Technical Service Bulletin: TSB101122

Released Date: 17-Jan-2011

New K38/50 and QSK38/50 Jumper Covers and Jumper Cover Gasket

Figure 2: Gasket (1) and Jumper Covers (2 and 3)

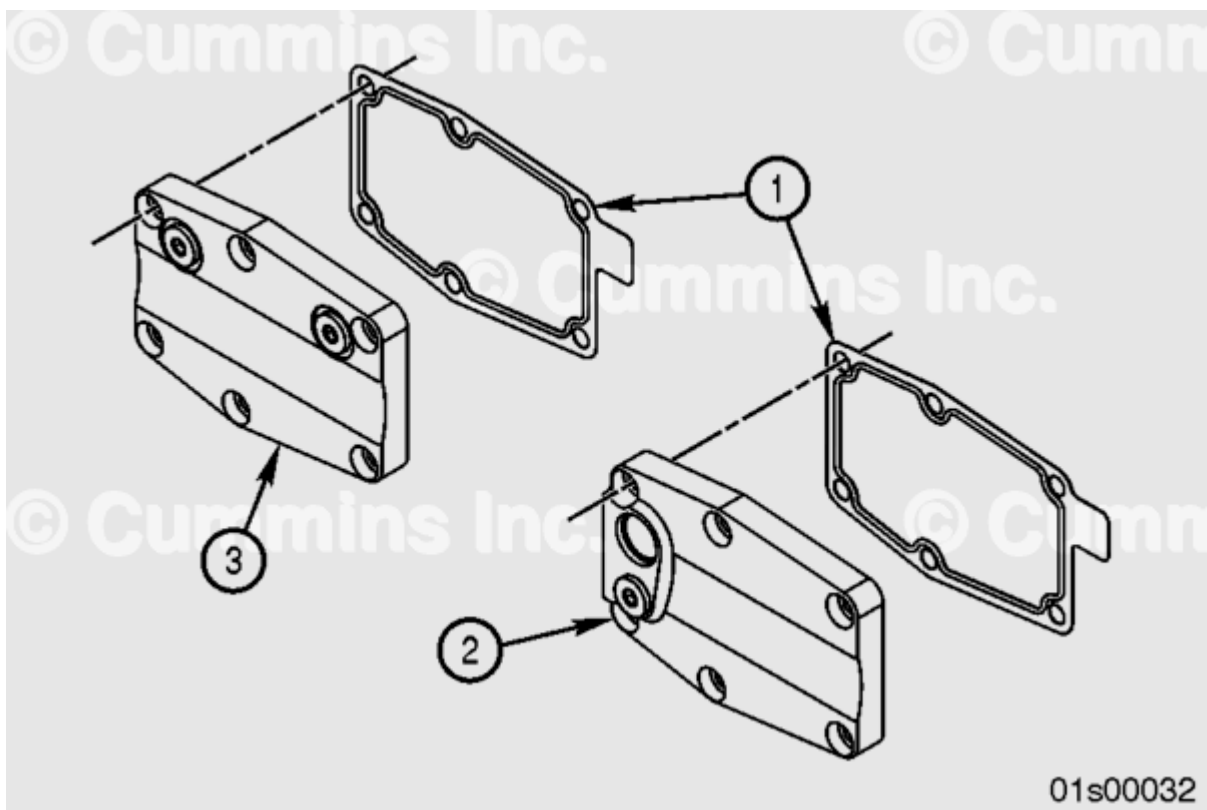
The jumper cover gasket material has been changed from steel core to edge molded to increase durability and reduce the potential for leaks.

Due to the new jumper cover gasket being slightly thicker, the jumper covers have been revised to prevent possible interference between the jumper cover and the engine starter motor.

The new jumper covers and gasket were released on December 20, 2010 for use in all K38, K50, QSK38 and QSK50 engines with ESN first 33184438.

Figure 3: Jumper Cover Thickness Measurement

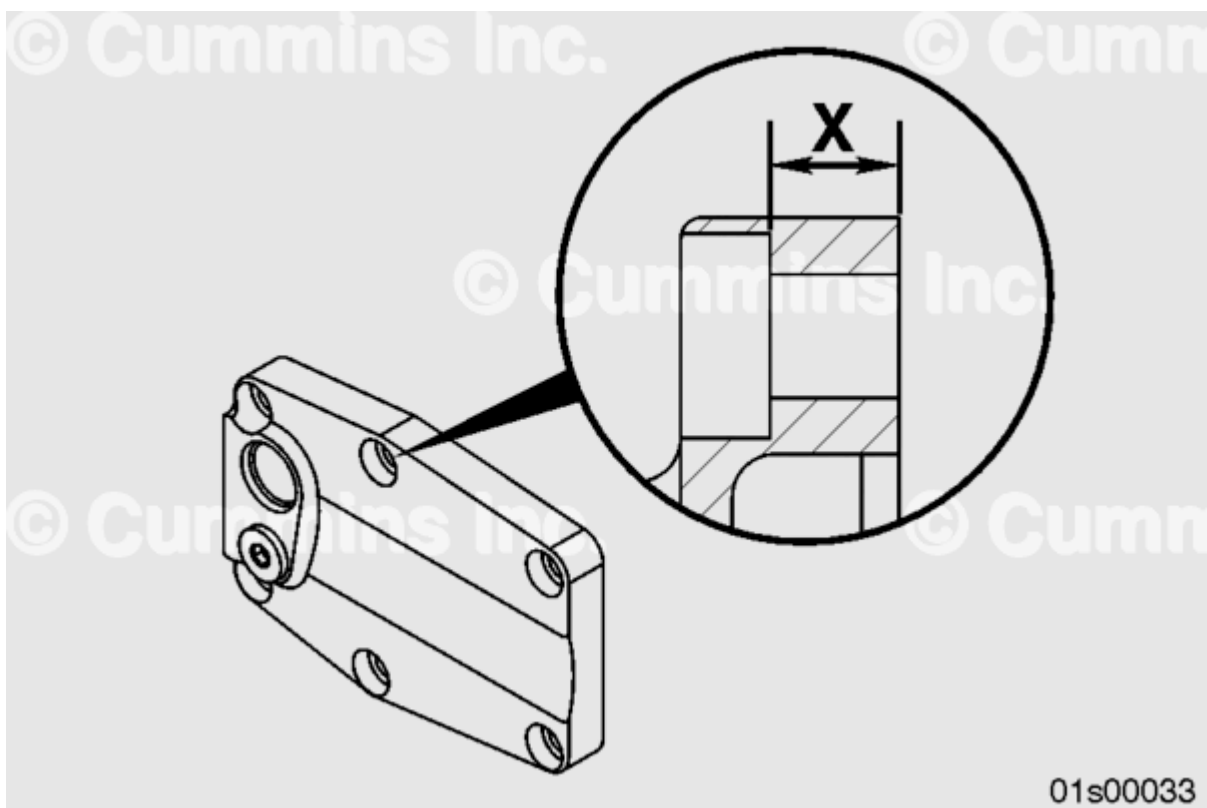
A jumper cover can be identified as old or new by either the part number, shown in the Table 1, or by measuring the cover thickness as follows:

- There are six counter-bored holes used to attach the cover to the cylinder block.
- Measure the thickness of the material between the bottom of the counter-bored hole and the machined face of the cover. See Figure 3.
- An old cover will have a thickness (dimension X in Figure 4) of 12 ± 0.38 mm [0.472 ± 0.0149 in]
- A new cover will have a thickness (dimension X in Figure 4) of 10.9 ± 0.38 mm [0.429 ± 0.0149 in]

Figure 4: Material to be removed from mating face of cover

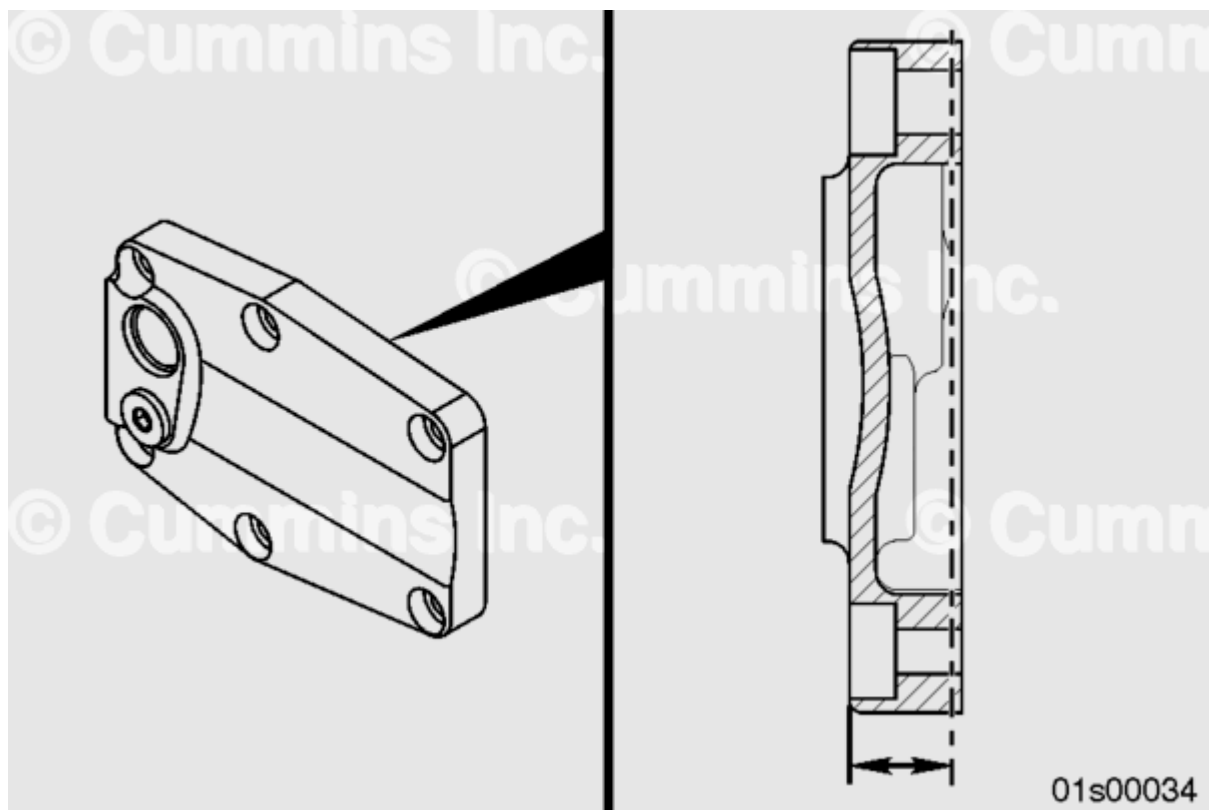
If a new, edge molded gasket is installed to an engine fitted with an old jumper cover, there is a possibility that there may be interference between the jumper cover and the starter. If there is an interference condition, there are two possible options:

- The jumper cover can be machined so that 1.1 mm [0.043 inch] of material is machined off of the mating face of the cover. See Figure 4. After machining, the surface should have a flatness of 0.25 deviation and a surface finish of 3.2 roughness average, maximum.
- The old jumper cover can be replaced with a new style cover.

Do **not** remove material from the outer surface of the cover, as the reduced wall thickness could result in a malfunction of the cover.
